Pending Amendments to Clauses in the Griffith University Design Guidelines & Procedures Version 18

Edition 18.4

Diagram 18.i

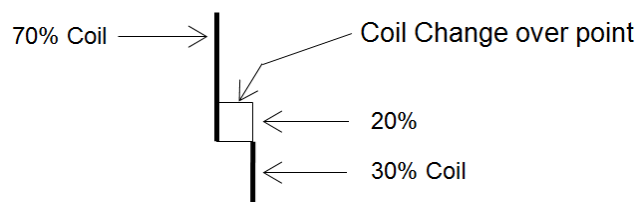
Delete existing paragraphs and replace with the following;

- If the load requires less than 50% of the cooling capacity of the large coil and the small coil is closed down, then the small coil shall be reactivated and the CW flow to both coils modulated to decrease the capacity of the large coil and increase the capacity of the small coil

- When the load has once again exceeded the 100% cooling capacity of the small coil, then the CW flow control outlined above will commence a new cycle.

The object of this operating strategy is to achieve the maximum amount of cooling required for the minimum amount of the coil cooling capacity available. This will also de-humidify the air and provide the potential to maintain comfort levels while allowing the temperature set point to be raised, with a consequent saving in energy.

Diagram 18.ii

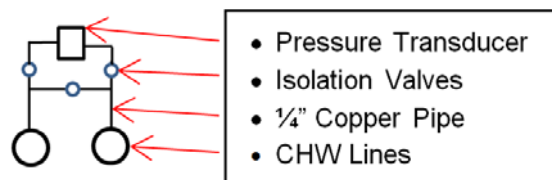
Insert the following at the end of the existing second paragraph;

The VSD of any secondary chilled water pump shall be controlled by a pressure transducer located in an easily accessible location at approximately two thirds (2/3) of the distance along the index chilled water pipe run. The pressure transducer pipework shall be configured as shown in the following Diagram 18.ii.

Diagram 18.iii

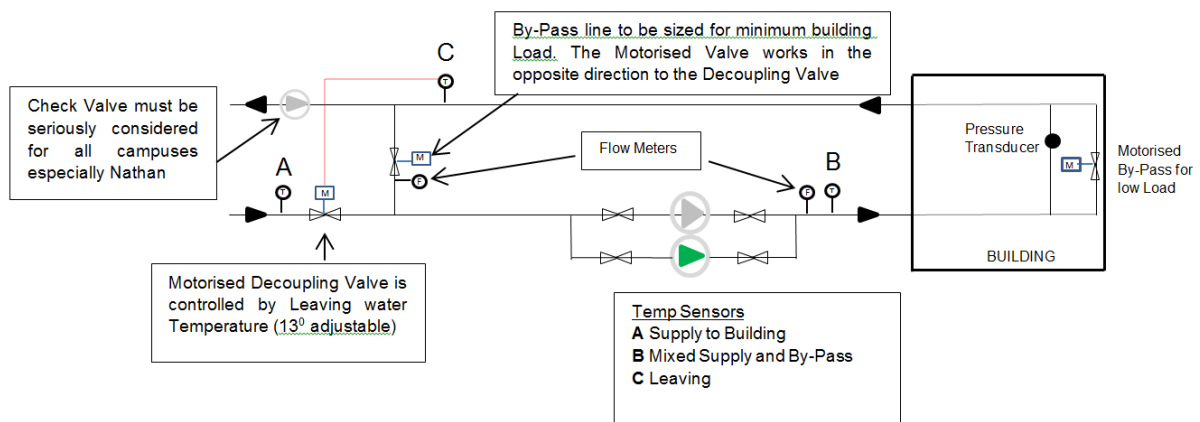
Insert following new paragraph between the existing fourth and fifth paragraphs;

Secondary Chilled Water Pipework Layout – The supply and return pipework within a building, shall incorporate the secondary pipework and control/monitoring valves and equipment as shown on the following Diagram 18.iii to maintain consistent water flows and temperature control throughout the building pipework system.
